NOTICE OF DECISION

TREE REGULATION VARIANCE / CLASS 2 DRIVEWAY APPROACH PERMIT CASE NO.: TRV-DAP25-01

NOTICE OF DECISION DATE: February 11, 2025

SUMMARY: Four Tree Regulation Variances and a Class 2 Driveway Approach Permit for development of a cottage cluster.

TREE REMOVAL PLAN

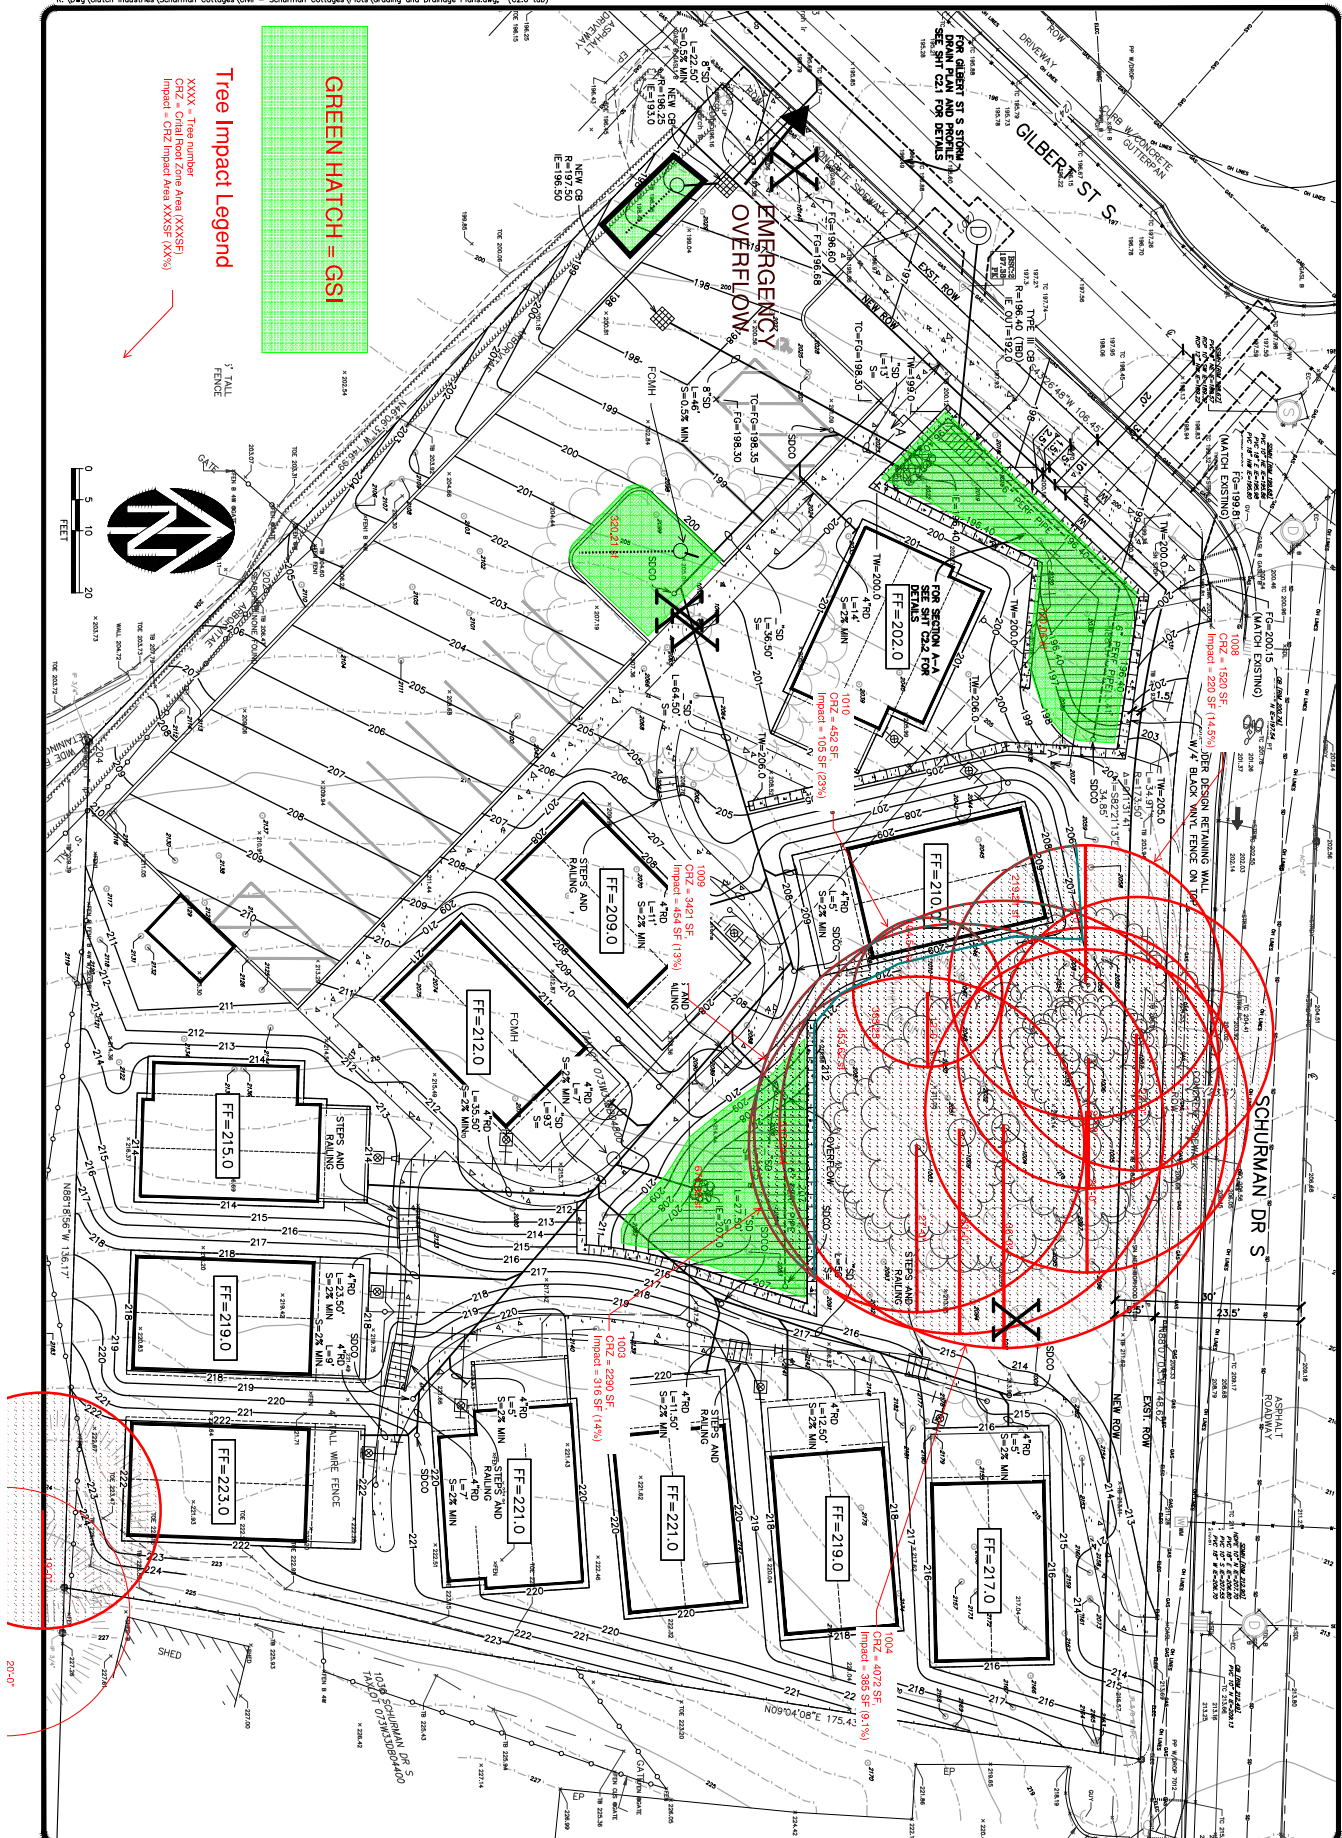
For the first two Tree Variance requests, the applicant has proposed to remove two trees, a 26-inch and a 32-inch Oregon White Oak (trees 1012 and 1013 on the plan), for the development of a proposed driveway and off-street parking area to serve the units. While off-street parking is not required for the proposed cottage cluster use, the applicant has proposed development of 11 off-street parking spaces to serve the units. Per the Special Use development standards of a cottage cluster under SRC 700.011(f), off-street parking areas shall not be located between the front property line abutting a street and those dwelling units within the cottage cluster that are located closest to the front property line abutting a street, unless the lot is a corner lot, then the off-street parking area may be located between the dwelling units and a side lot line abutting a street. The property is a corner lot abutting Schurman Drive S and Gilbert Street S; therefore, the front property line can be either street-abutting property line, provided it meets lot standards.

Of the other significant trees on the property, the applicant has proposed to preserve eight of the trees which are grouped within the center of the site, creating a courtyard space for the cottage units. The applicant's plans and written statement indicates the critical root zone of one of the trees, a 51-inch DBH Oregon White Oak (tree 1011 on the plan), will be impacted by the construction. As defined in SRC 808.005, the *critical root zone* is "the circular area beneath a tree established to protect the tree's trunk, roots, branches, and soil to ensure the health and stability of the tree. The critical root zone measures one-foot in radius for every one-inch of DBH of the tree." Based on the tree's 51-inch DBH, the critical root zone measures 51 feet in radius. Per SRC 808.046(a)(1)&(2), all protected trees, including 100 percent of their critical root zone, shall be protected during construction; however, SRC 808.046(a)(3) allows "up to a maximum of 30 percent of the critical root zone of a tree may be disturbed in order to accommodate development of property when a report from an arborist is submitted documenting that such disturbance will not compromise the long-term health and stability of the tree and all recommendations included in the report to minimize any impacts to the tree are followed." As defined in SRC 808.005, *tree removal* includes the cutting or removal of 30 percent or more of the tree's roots. Because the applicant's proposed development will encroach more than 30 percent of the tree's critical root zone, meeting the definition of removal, the applicant has requested a tree variance to this standard. The applicant has demonstrated that due to the size and configuration of the lot and the location of tree 1011 in the middle of the subject property, the protection measures create a practical difficulty to the otherwise reasonable development of the property, that can most effectively be relieved by approval of the variance. To ensure the proposed development will not severely impact the tree, the following conditions shall apply.

- Condition 2:** A licensed arborist shall be on site to conduct any excavating and cutting of the roots of the significant Oregon White Oaks on the property (trees 1003, 1004, 1005, 1006, 1007, 1008, 1009, and 1011 on the attached plan).

corridor trees. The applicant's tree inventory and written statement indicate that there was a total of 17 trees on the subject property and that the applicant has already removed five, or 29 percent ($5 / 17 = 0.29$) in the previous year 2024. None of the five trees previously removed were significant, heritage, or riparian corridor trees. The applicant has requested to remove an additional 10-inch Poplar tree (tree 1014 on the attached plan) within the area of the proposed driveway approach. With the requested removal of the two other significant trees, and the encroachment into the third, previously addressed, nine total trees are proposed for removal, or 53 percent ($9 / 17 = 0.53$) within a five-year period.

Finding: The preliminary site plan shows a retaining wall within the required vision clearance area for the Driveway Approach. The site plan does not provide details regarding the height of the retaining wall. SRC 805.010 prohibits obstructions to vision clearance from 30 inches above curb level to 8.5 feet above curb level; it is unclear from the information provided if the retaining wall complies with the 30-inch height restriction. As a condition of approval, prior to building permit issuance the applicant shall submit a site plan demonstrating the driveway approach serving the proposed cottage cluster development complies with applicable Vision Clearance Standards in SRC Chapter 805. With this condition of approval, the driveway approach will comply with the Vision Clearance Standards established in SRC Chapter 805.

- Condition 1:** At time of building permit, the applicant shall provide a report from a licensed arborist demonstrating the proposed development will not adversely impact tree 1011.

- Condition 3:** During construction, an above ground silt fence or its equivalent shall encompass 100 percent of the critical root zone of the significant Oregon White Oaks, except where the arborist's report indicates less than 30 percent of the critical root zones will be impacted. Within the area protected by the above ground silt fence, the tree's trunk, roots, branches, and soil shall be protected to ensure the health and stability of the tree; and there shall be no grading, placement of fill, storage of building materials, or parking of vehicles.

Condition 4: Prior to building permit issuance, the applicant shall submit a site plan that demonstrates the proposed driveway approach serving the development is in compliance with applicable vision clearance requirements of SRC Chapter 805.
